**RE: File No. 11750 – Healy Public Safety Building - RTU Replacement - Addendum No. 5**

# Healy Public Safety Building RTU Replacement, File # 11750

## ADDENDUM # 5

Sheet No.  
**SKM-1**  
9/19/24

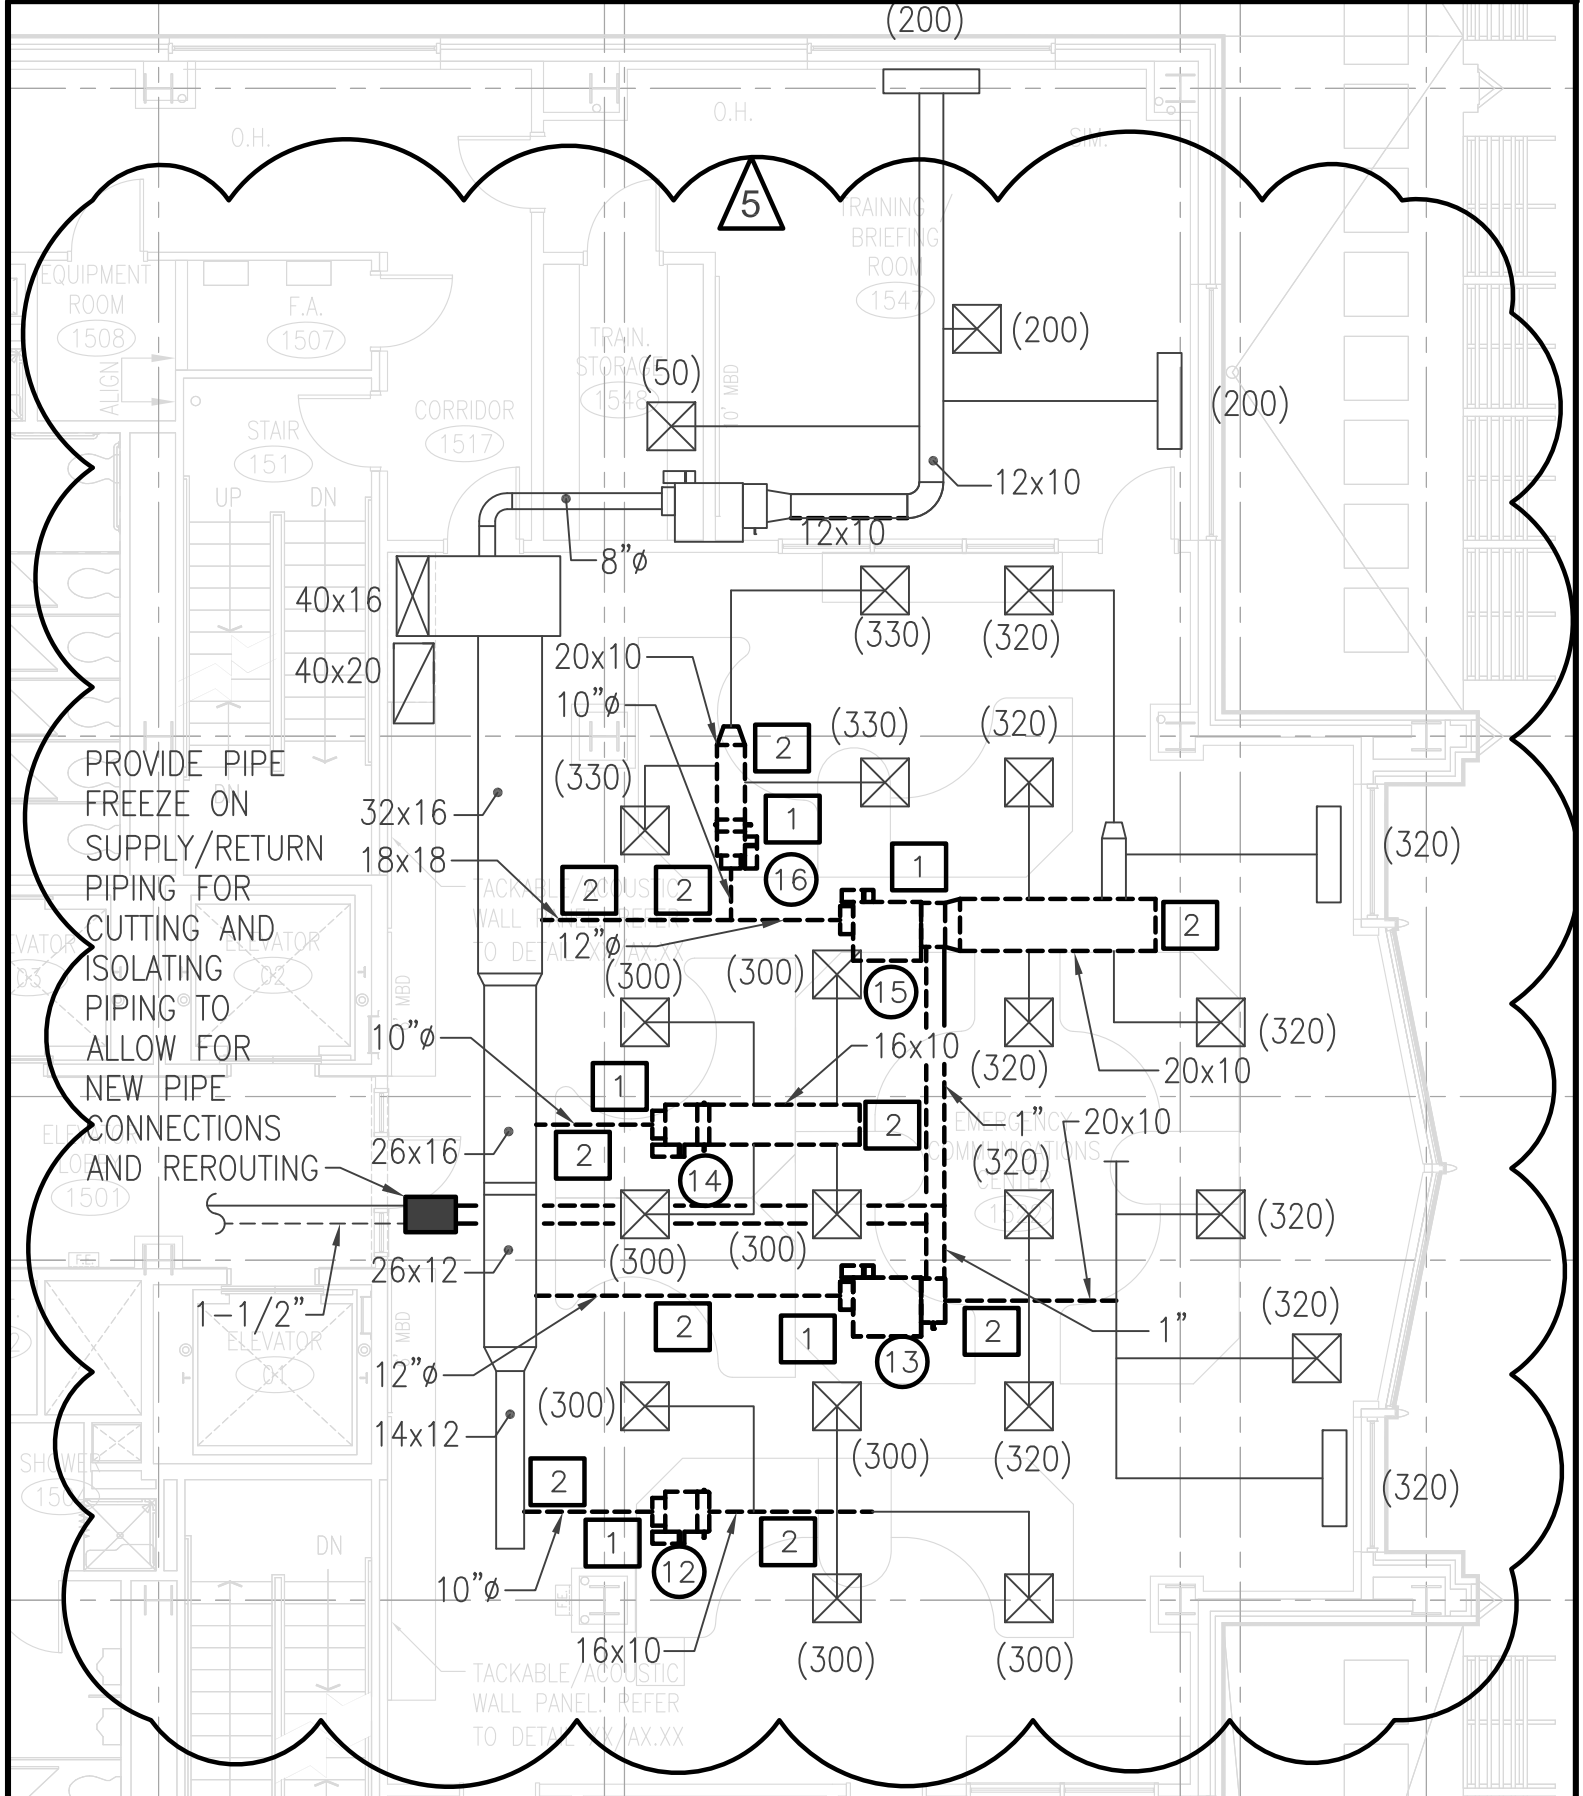
**1** EXISTING VAV BOX TO BE REMOVED IN ITS ENTIRETY INCLUDING ALL DUCTWORK TO LIMITS SHOWN, CONTROL WIRING, HANGERS, INSULATION AND ALL RELATED APPURTENANCES. REFER TO NEW WORK DRAWING FOR NEW VAV'S IN NEW LOCATIONS AND PROVIDE NEW DUCTWORK AT DUCT SIZES INDICATED AND TO LIMITS SHOWN. PROVIDE NEW VAV CONTROLS AND RE-CONNECT TO EXISTING MS/TP BMS LOOP. UPDATE GRAPHICS ON BMS AND CALIBRATE/BALANCE AS REQUIRED

**2** DISCONNECT AND REMOVE EXISTING DUCTWORK INDICATED AS DASHED LINES INCLUDING INSULATION, HANGERS AND DAMPERS. CONNECT NEW DUCTWORK TO NEW VAV AND EXISTING DUCTWORK, PROVIDE VOLUME DAMPER AT EACH DUCT CONNECTION INCLUDING MAINS AND BRANCH DUCTS. PROVIDE NEW DUCT HANGERS AND DUCT INSULATION AS SPECIFIED. RECONNECT EXISTING BRANCH DUCTS TO NEW MAIN DUCTS

**3** DISCONNECT AND REMOVE EXISTING PIPING INDICATED AS DASHED LINES INCLUDING INSULATION, HANGERS AND VALVES. CONNECT NEW PIPING TO NEW VAV'S AND EXISTING MAINS, PROVIDE ISOLATION VALVES OFF OF MAINS. PROVIDE NEW PIPE HANGERS AND PIPE INSULATION AT 1-1/2" THICK WITH AN ASJ. RECONNECT NEW PIPING TO EXISTING MAINS.

Sheet No.  
**SKM-3**  
9/19/24

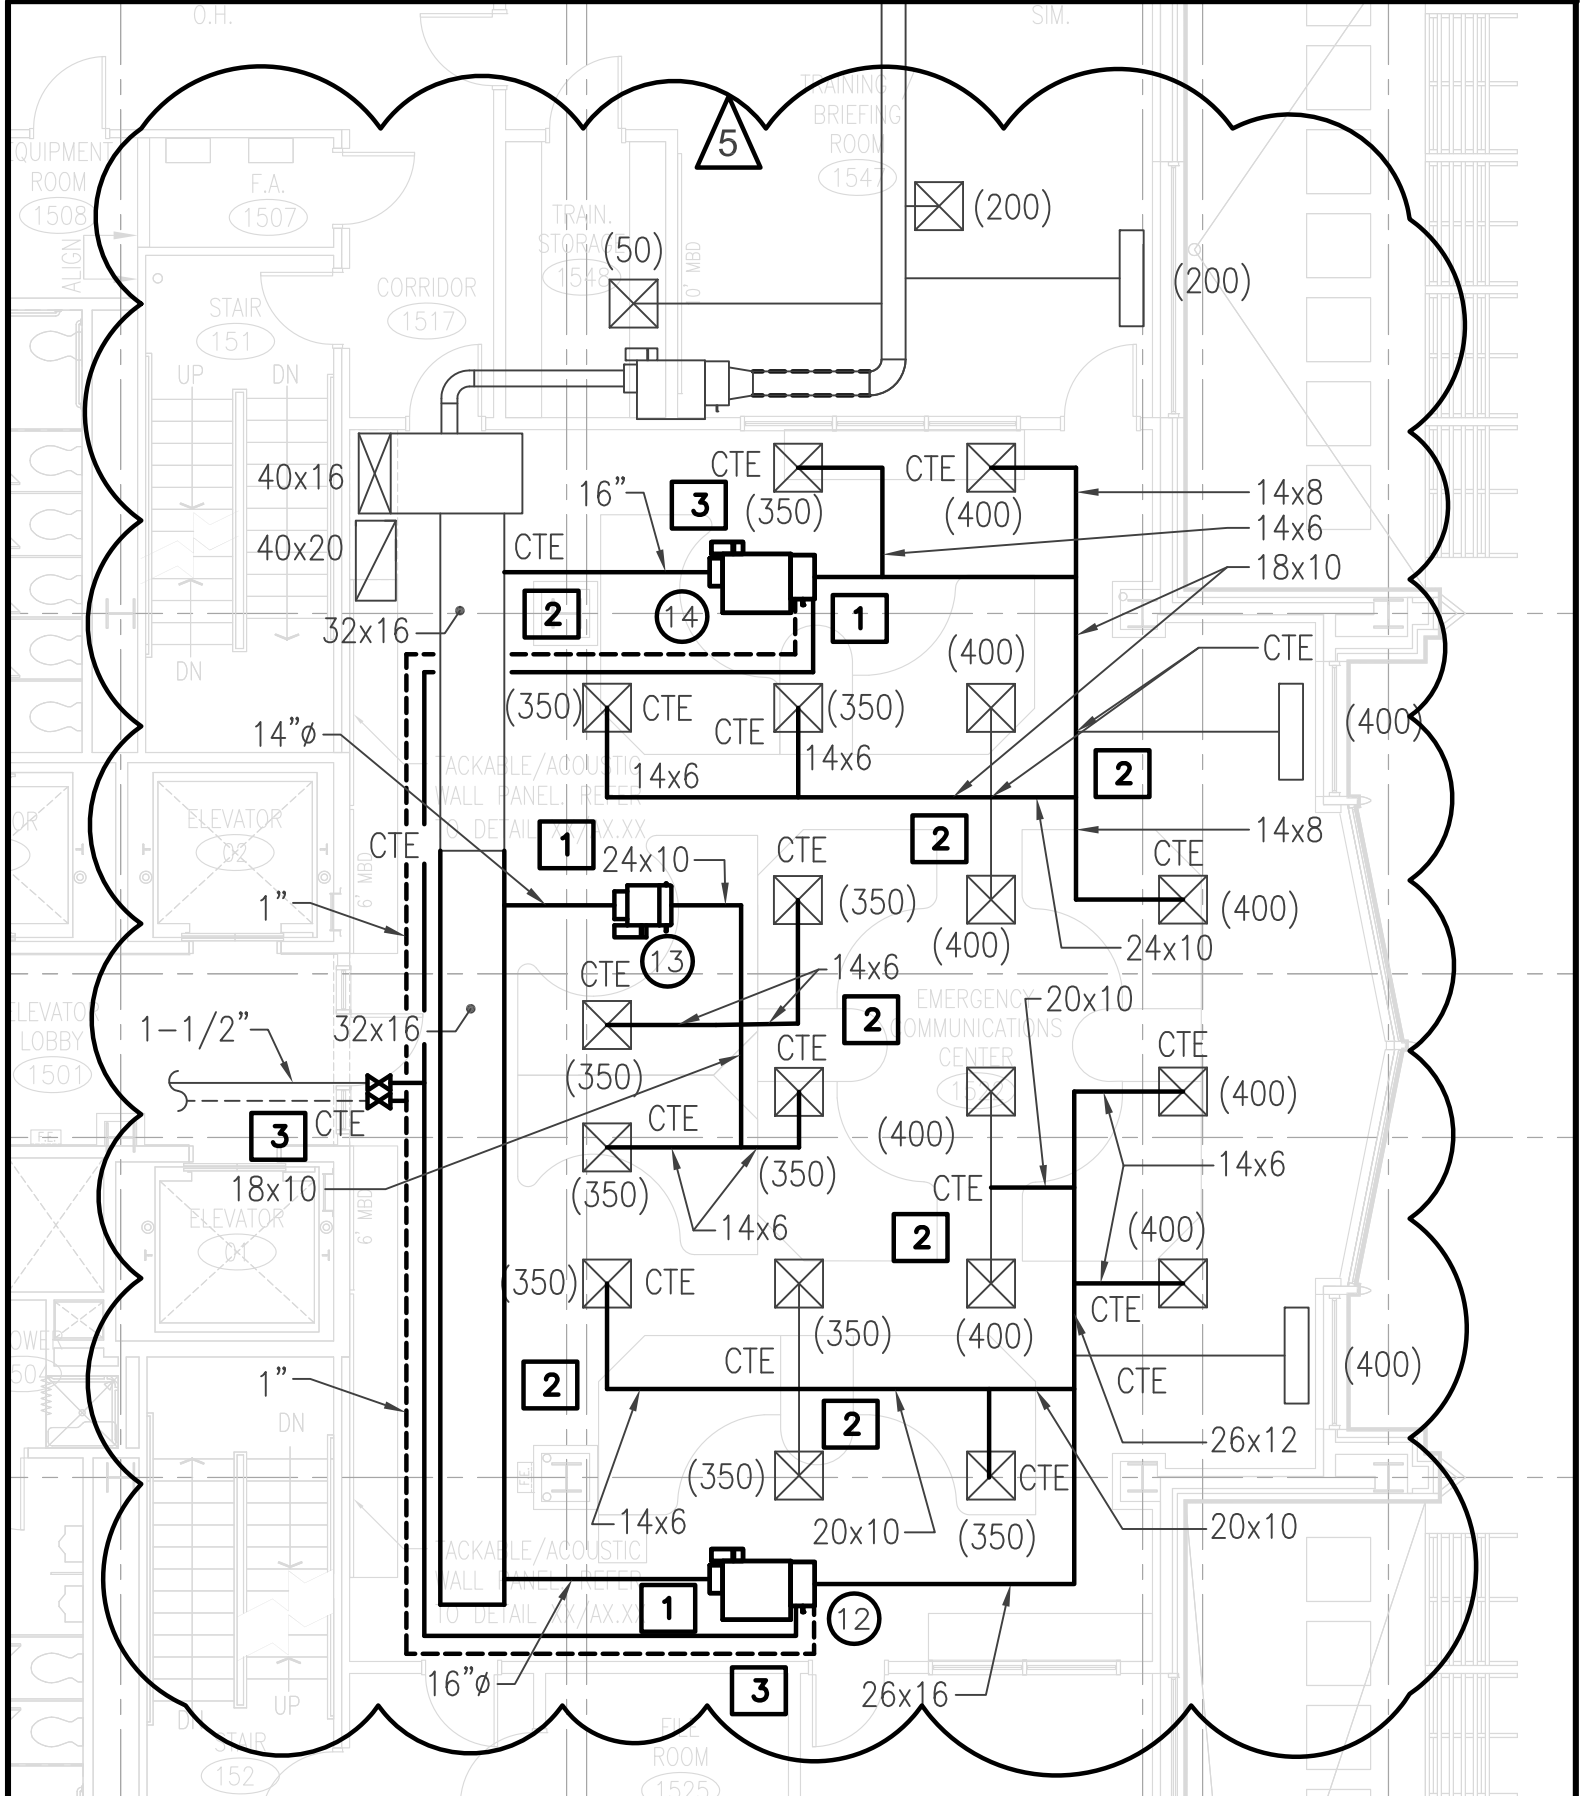
- 1** PROVIDE AND INSTALL NEW VAV BOX IN NEW LOCATIONS AND PROVIDE NEW DUCTWORK AT DUCT SIZES INDICATED AND TO LIMITS SHOWN. PROVIDE NEW VAV CONTROLS AND RE-CONNECT TO EXISTING MS/TP BMS LOOP. UTILIZE EXISTING THERMOSTATS AND RECONNECT TO NEW VAV CONTROLLERS. REMOVE THERMOSTATS AND WIRING FROM EXISTING VAV UNITS THAT HAVE BEEN REMOVED. UPDATE GRAPHICS ON BMS AND CALIBRATE/BALANCE AS REQUIRED
- 2** PROVIDE AND CONNECT NEW DUCTWORK TO NEW VAV AND EXISTING DUCTWORK, PROVIDE VOLUME DAMPER AT EACH DUCT CONNECTION INCLUDING MAINS AND BRANCH DUCTS. PROVIDE NEW DUCT HANGERS AND DUCT INSULATION AS SPECIFIED.
- 3** PROVIDE AND CONNECT NEW PIPING TO NEW VAV'S AND EXISTING MAINS, PROVIDE ISOLATION VALVES OFF OF MAINS. PROVIDE NEW PIPE HANGERS AND PIPE INSULATION AT 1-1/2" THICK WITH AN ASJ.

**TYPICAL VAV BOX ASSEMBLY DETAIL**

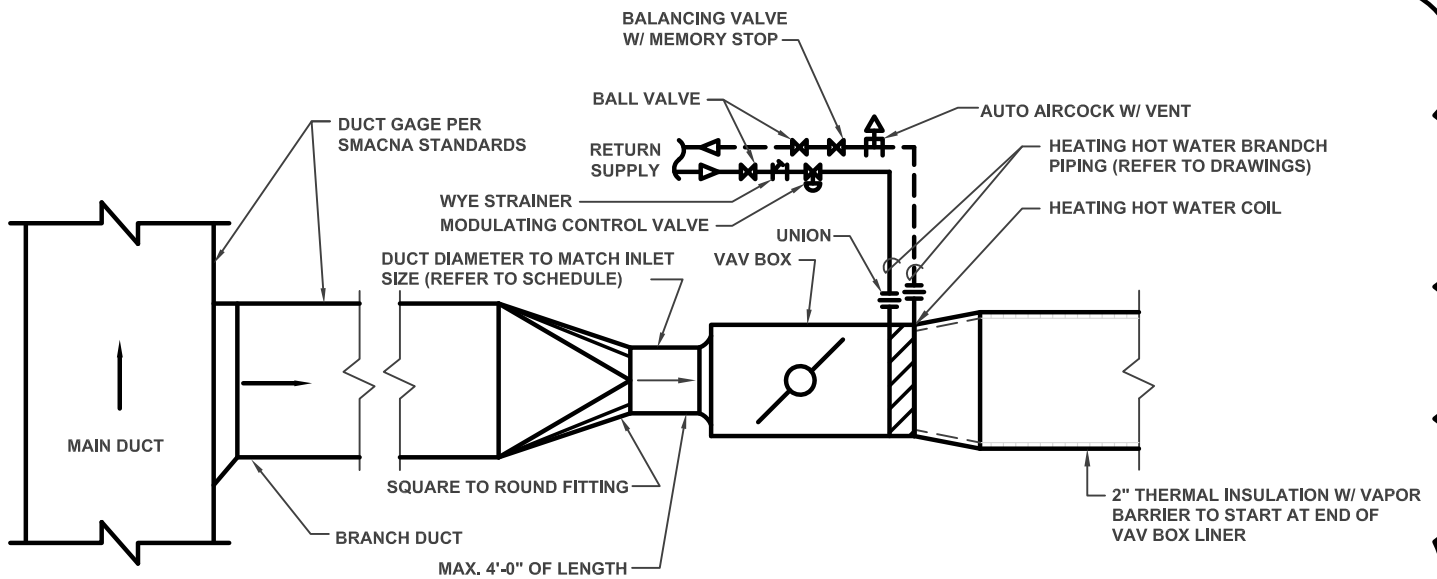
NOTE #1: REMOVE THE EXISTING INLET DUCT IN ITS ENTIRETY FOR ASSOCIATED VAV AND PROVIDE A NEW INSULATED INLET SUPPLY DUCT PER THE CONTRACT DOCUMENTS. CONNECT NEW INLET VAV DUCT TO EXISTING MAIN SUPPLY DUCT AND NEW VAV, PROVIDE ALL NECESSARY FITTINGS, HANGERS, INSULATION AND DUCT SEALANT AS REQUIRED FOR A COMPLETE DUCTED SYSTEM. CONNECT NEW VAV OUTLET TO EXISTING DUCTWORK OR EXISTING DIFFUSER. PROVIDE ALL NECESSARY DEMO OF EXISTING DUCT, AND ANY NEW FITTINGS, HANGERS, INSULATION AND FASTENERS.
